Access Compliance Report

Public Rights-of-Way

Intersection ID: 49176	Main Street: MCKEE_RD	Cross Street: FRED_GUTT_DR	Location: SE
ADA ID: C45BA161BC46	Ramp Type: PerpDiag	Initial Pass/Fail: Fail	Overall Compliance: No
		Severity Score: 10

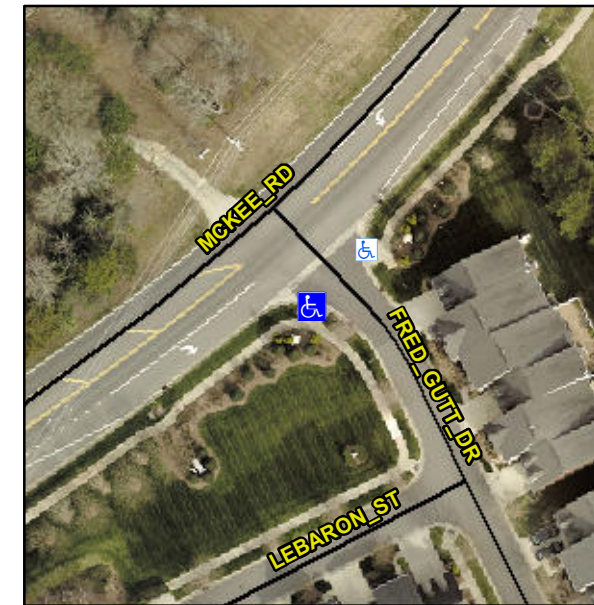
Not Found, R304.5.1, R304.5.3

Compliance	Description	Data	Compliance	Description	Data
N/A	Ramp Length (in)	95.0	Yes	Ramp Slope (%)	7.4
No	Ramp Width (in)	45.0	No	Ramp XSlope (%)	2.8
N/A	Flare Type LT	N/A	N/A	Flare Type RT	N/A
N/A	Flare Slope LT (%)	N/A	N/A	Flare Slope RT (%)	N/A
N/A	Flare Traversable LT?	N/A	N/A	Flare Traversable RT?	N/A
N/A	Landing Length (in)	N/A	N/A	DWS Provided?	N/A
N/A	Landing Width (in)	N/A	N/A	DWS Contrast?	N/A
N/A	Landing Slope (%)	N/A	N/A	DWS Length (in)	N/A
N/A	Landing X Slope (%)	N/A	N/A	DWS Full Width?	N/A
N/A	Landing Curb? (Y/N)	N/A	N/A	DWS Offset (in)	N/A
N/A	Shared Landing?	N/A			
N/A	Gutter Ponding?	N/A	N/A	Gutter Slope (%)	N/A
N/A	Gutter Lip Ht (in)	N/A	N/A	Gutter X Slope (%)	N/A
N/A	Painted X Walk1?	No	N/A	Painted X Walk2?	No
	X Walk 1 Direction	To NE		X Walk 2 Direction	To NW
N/A	X Walk 1 Width (in)	N/A	N/A	X Walk 2 Width (in)	N/A
	X Walk 1 Slope (%)	1.3		X Walk 2 Slope (%)	3.8
	X Walk 1 X Slope (%)	2.2		X Walk 2 X Slope (%)	1.0

Remove & Replace Curb Ramp With Two New Directional Ramps or Equivalent.
